Re: Revised Corning Subbasin Groundwater Sustainability Plan

AquAlliance submits additional comments and questions on the revised Corning Subbasin Groundwater Sustainability Plan (“revised GSP” or “revised Plan”) that was made available on April 9, 2024. The 2022 GSP was deemed “Incomplete” by DWR. Serious flaws remain in the revised Plan.

Figure 6-9. Predicted Impacted Wells at Minimum Thresholds

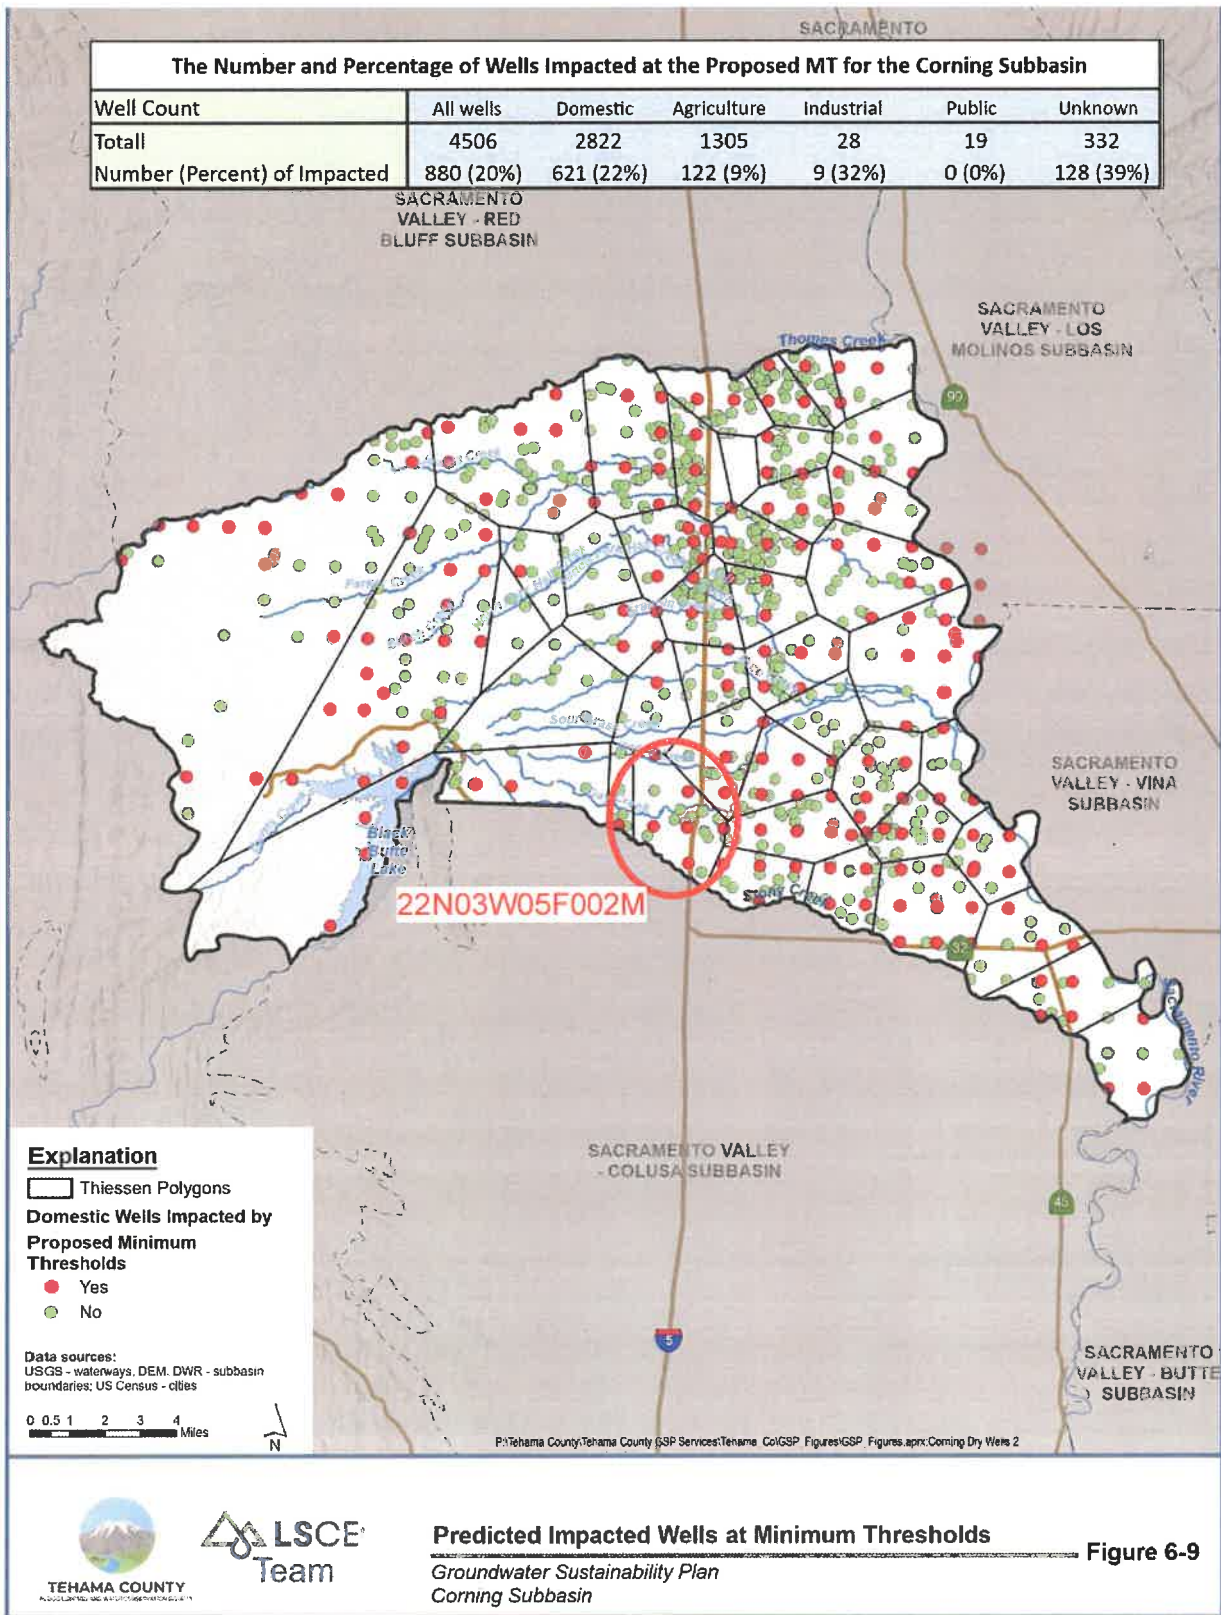
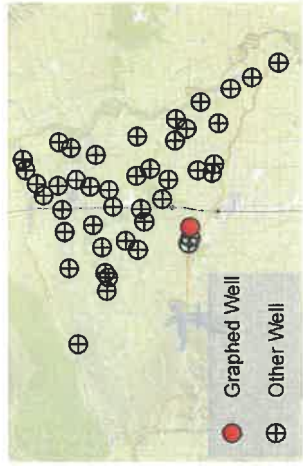
2. Figure 6-9 shows the *Predicted Impacted Wells at Minimum Thresholds* as those domestic wells with red dots (pdf p. 443). At the top of the figure is a table that lists the total number of wells by type, the number of wells in each type that will be impacted by the proposed revised Minimum Thresholds (MTs) and the percentage of impacted wells. A red oval has been overlain

on Figure 6-9 above the Thiessen polygon around RMP well 22N03W05F002M. Attached pdf pages 909 and 973 are the hydrographs from the revised GSP for this RMP well. This RMP well is outside of the Focus Areas or Zone of Special Concern. The MT elevation listed on the hydrographs is unchanged from the original GSP MT elevation of 177.9 feet, presumably because the average annual rate of groundwater decline is only -1.42 ft/yr. The pdf page 973 hydrograph shows the dry well percentile elevations and the number of wells that will be impacted when the groundwater level declines below the percentile elevation. The legend of the hydrograph indicates that if the groundwater level drops below the 20th percentile depth, 30 wells will go dry. The table at the bottom of pdf page 973 indicates that there are 101 domestic wells in the polygon around RMP well 22N03W05F002M and that 43 wells, or 31%, will be impacted by the proposed MT. It is unclear from this table whether the 41 wells have already been impacted, given the recent groundwater levels have declined below the 20th percentile elevation, or whether a total of 41 wells will be impacted whenever the groundwater level declines below the MT elevation. Regardless, the fact that this RMP well and the associated polygon are not included in the Focus Area or Zone of Special Concern apparently because the rate of groundwater decline hasn't yet reached -1.5 ft/yr even though there is a potential that 31% or 43 out of 101 wells will be impacted by the MT, seems to suggest that the -1.5 ft/yr threshold for defining the Focus Areas or Zone of Special Concern is arbitrary and lacking in a clear justification.

In summary, the revised GSP proposes a Well Mitigation Program that will provide resources to mitigate approximately 150 out of the 621 domestic wells the GSP will impact, 22% of a total of 2,822 wells (Figure 6-9, p. 6-29, pdf p. 443) Wells that are determined by the GRAs to be eligible for the program must match specific criteria that are yet to be determined and will be paid for by funding sources that are yet to be located. The GSAs adopted a resolution to commit to develop this Well Mitigation Program by January 1, 2026. "The Program shall cover eligible mitigation as of the Program start date and shall continue thereafter until groundwater sustainability is achieved during the GSP Implementation Period, or as otherwise directed by the District" (Appendix 7H, pdf p. 1375).

Corning Subbasin – State Well Number (SWN) 22N03W05F002M

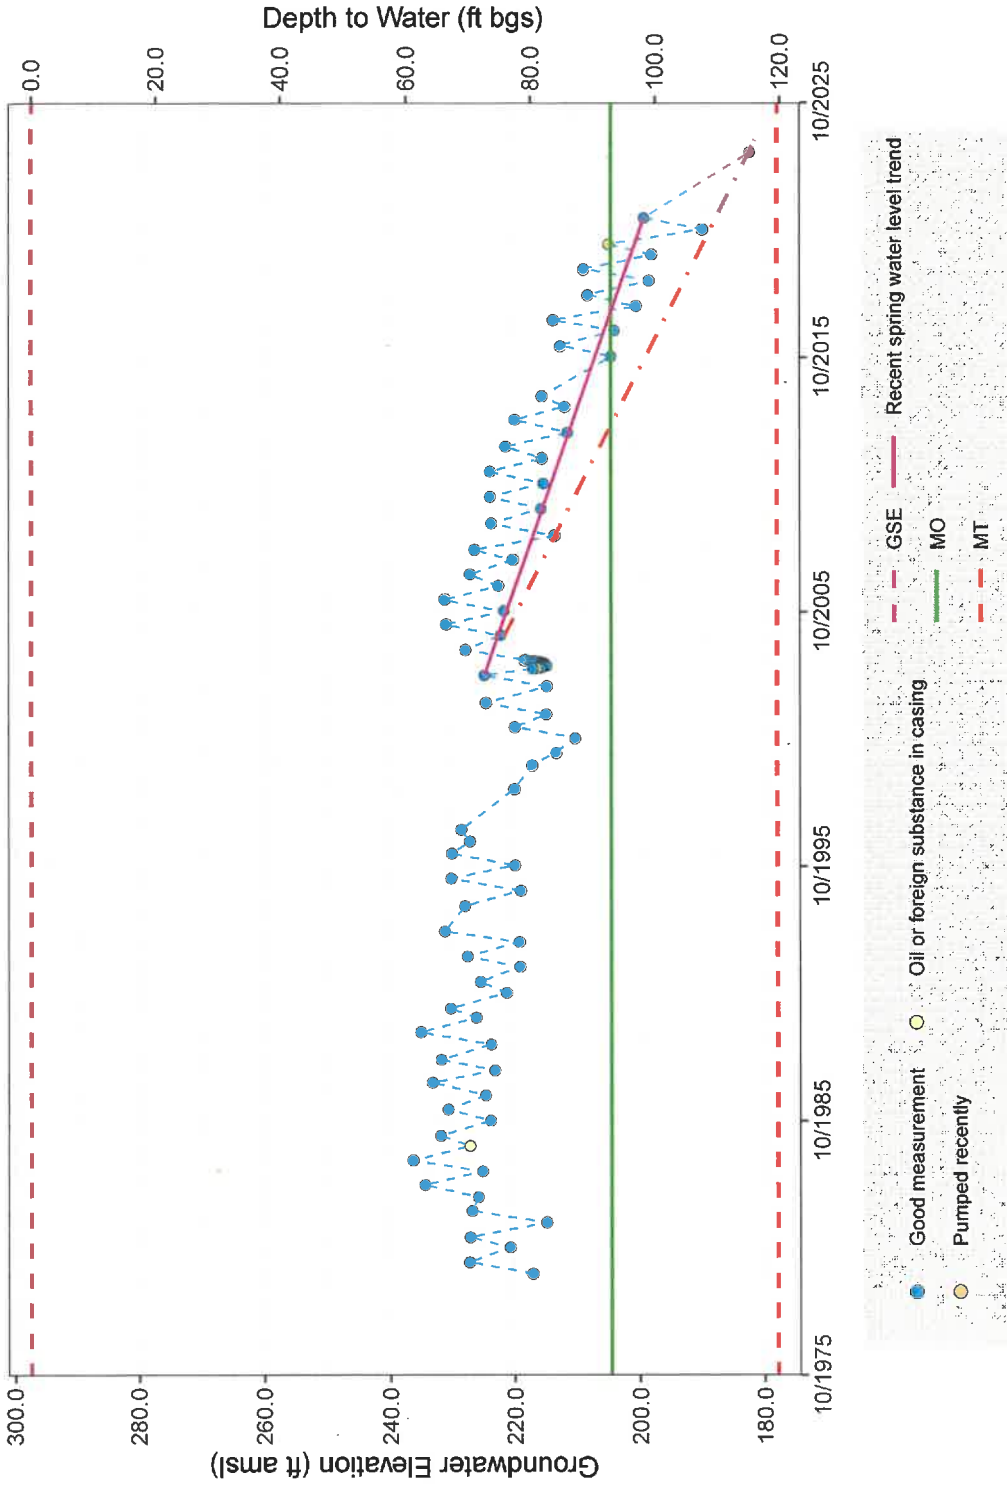
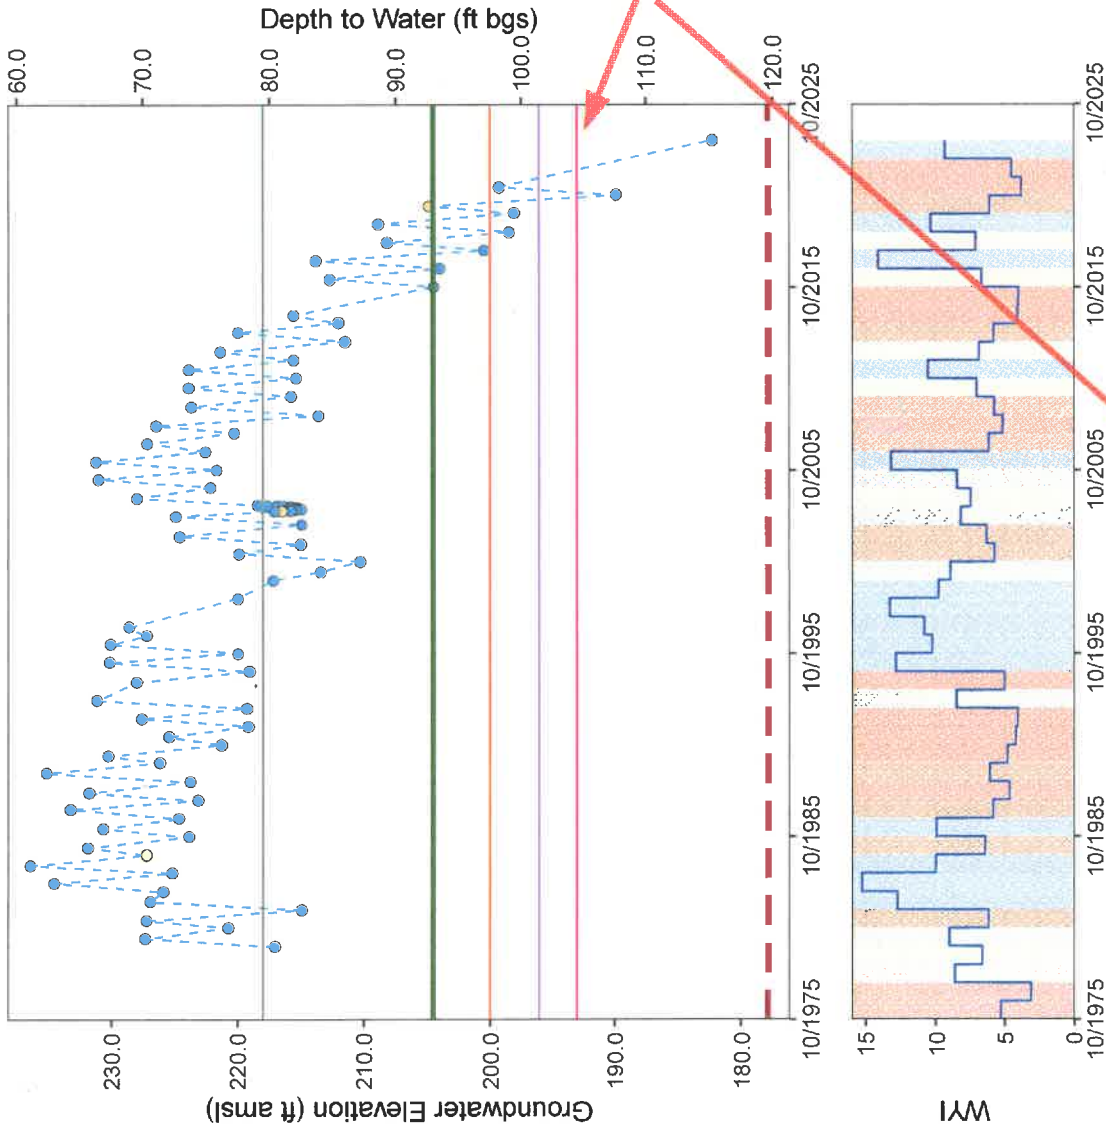
As discussed above, the reasoning for selecting the -1.5 ft/yr threshold, which sums to the proposed -7.5 ft or more decline in 5 years alternative, isn't clearly linked to the potential for impacts, such as the number of dry wells. An example was given above for RMP well 22N03W05F002M where a significant number of dry wells will occur even though the groundwater level is declining at a rate slower than -1.5 ft/yr. In addition, the linkage isn't clear between these two alternative triggers for undesirable results from the chronic lowering of groundwater and the undesirable results that occur whenever the proposed MT groundwater elevations are exceeded. The lack of clarity on why these alternatives or the MT elevations are determined to be an undesirable result seems to contradict DWR's requirement to "...clearly describe the significant and unreasonable conditions the GSAs are managing the Subbasin to avoid" and lacks the "...quantitative description of the negative effects to beneficial uses and users that would be experienced at undesirable result conditions.”
